ADDENDUM 003 Request for Bid New Linn Maintenance Complex Project RFB 9-161004KH

Linn Maintenance Building
Central District - Osage County
143 Commercial Drive, Linn, MO 65051

ADDENDUM #3

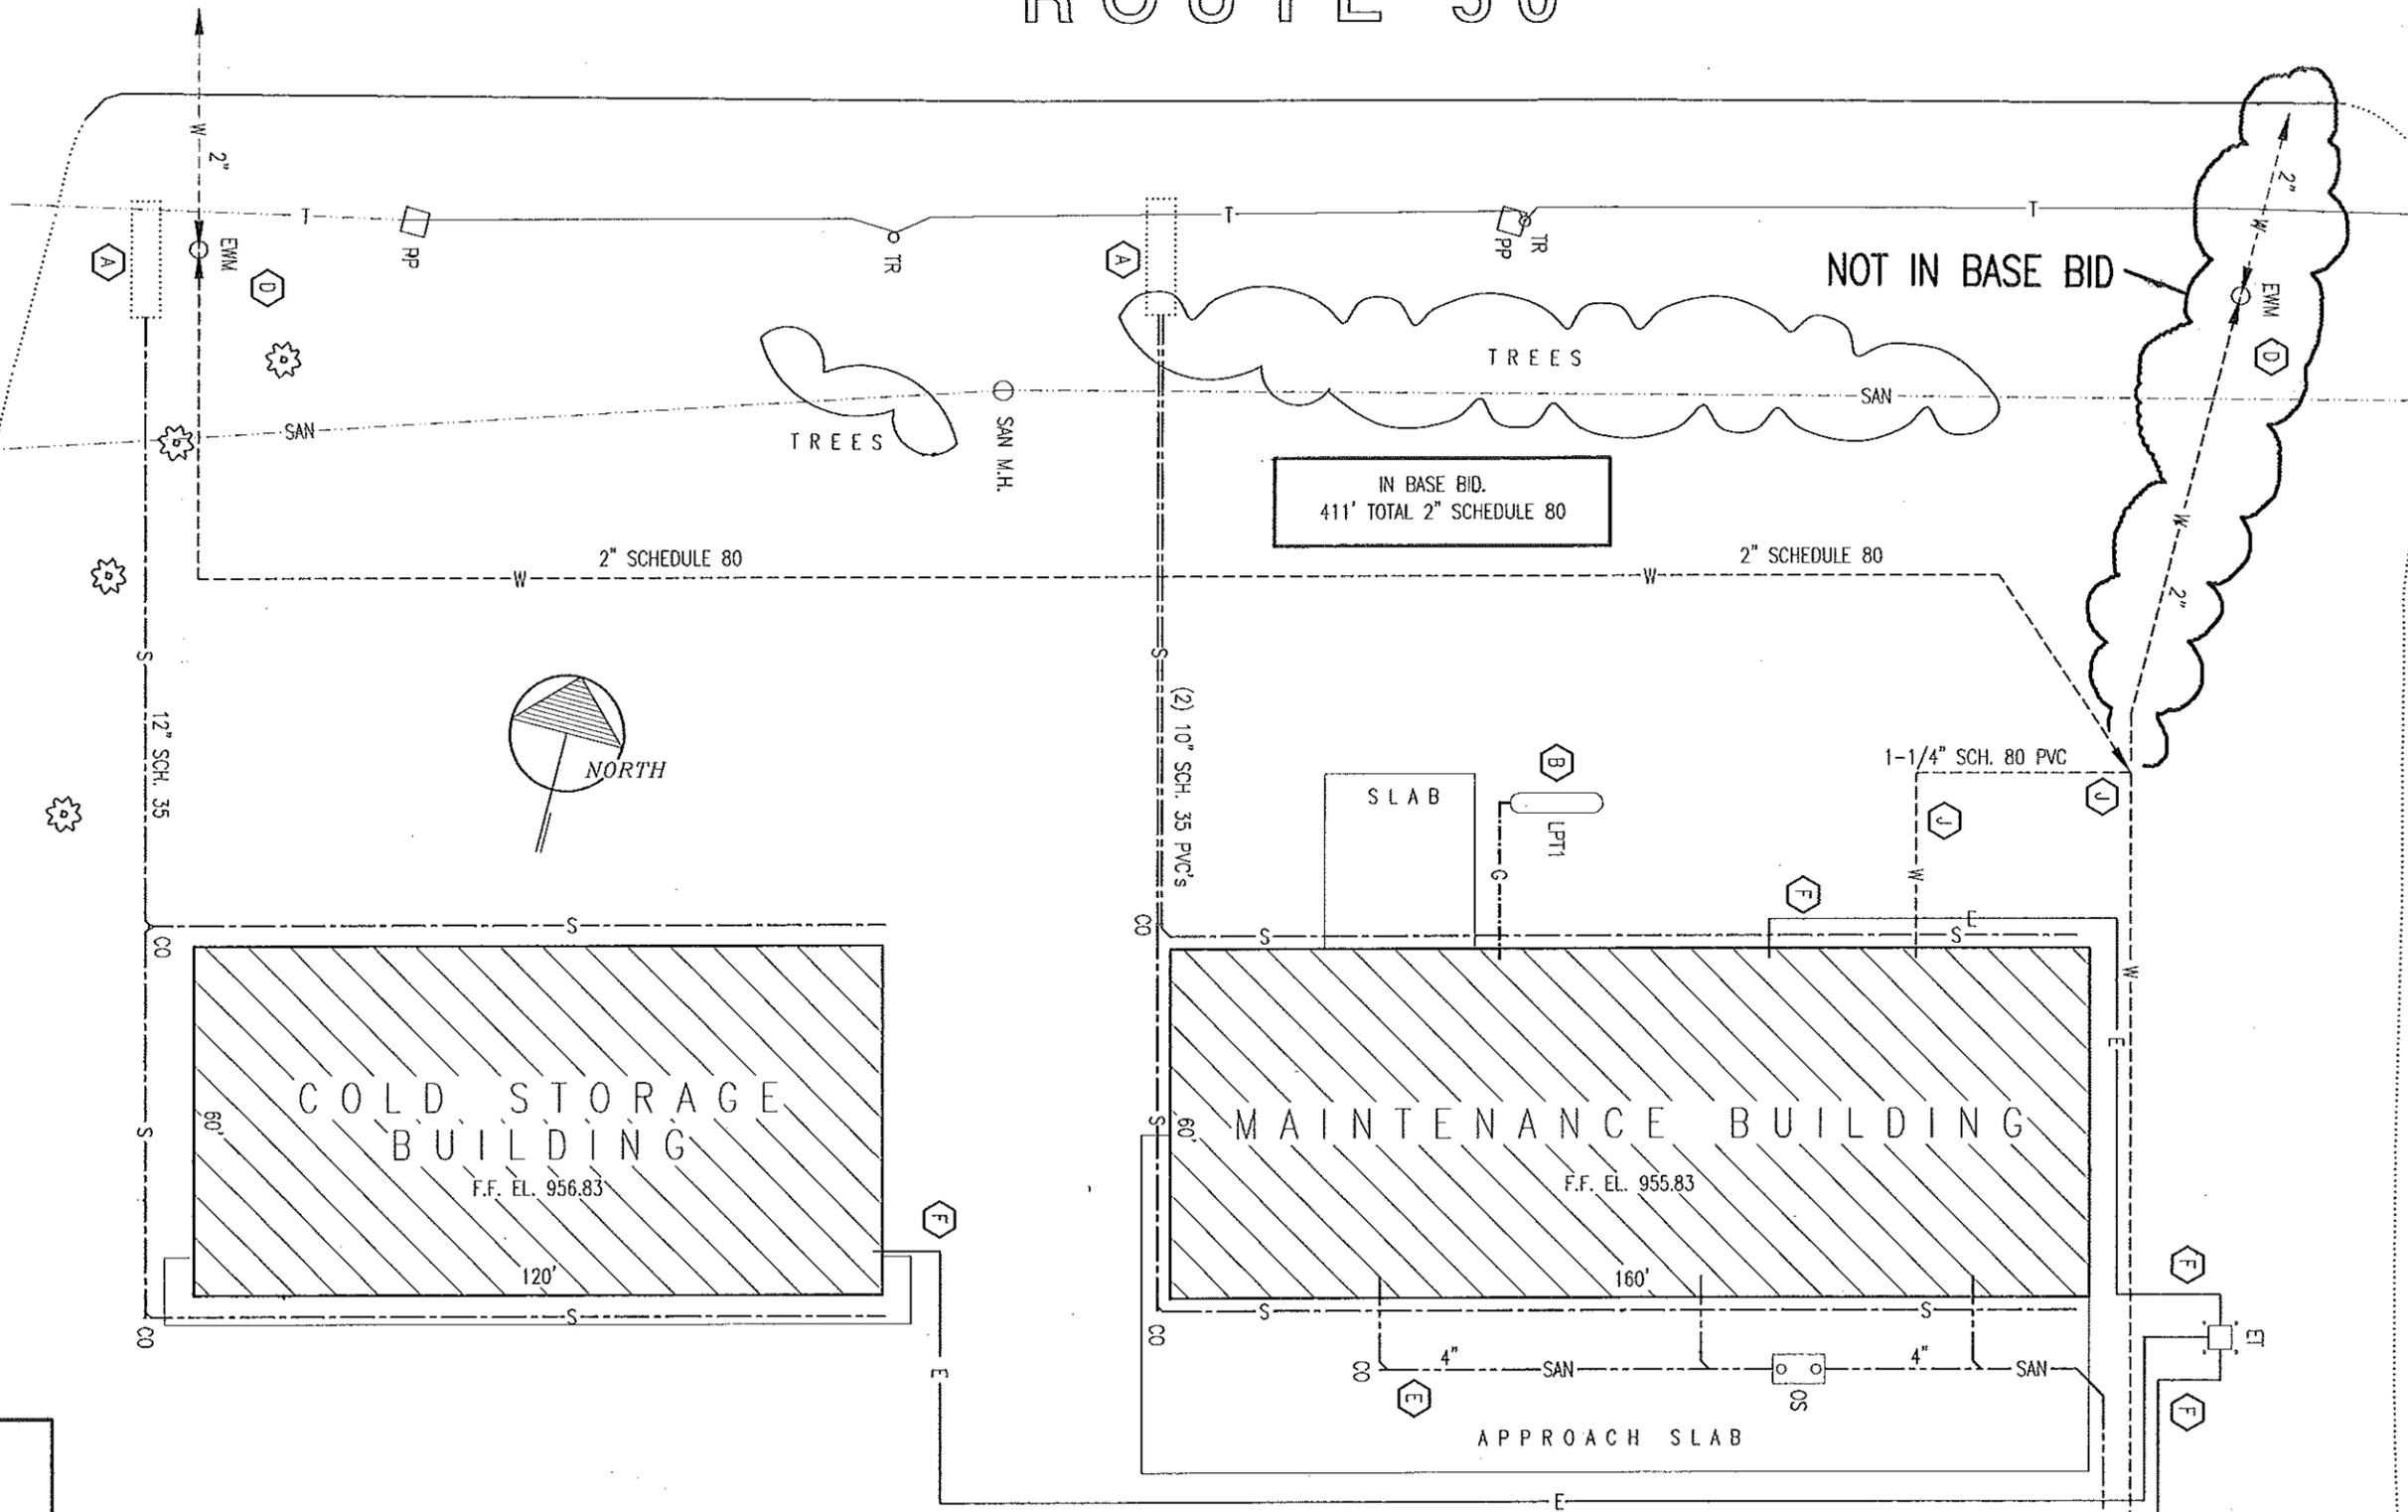
Changed as noted on Addendum #3 *Sheet 1 of 1*: Remove from base bid 84' of 2" schedule 80 waterlines from water meter to note "J".

Changed as noted on Addendum #3 *Sheet 1 of 1*: Include in base bid 411' of 2" schedule 80 waterline starting at the NW corner of MoDOT property/meter running eastward to note "J" or 1 ¼" schedule 80 waterline.
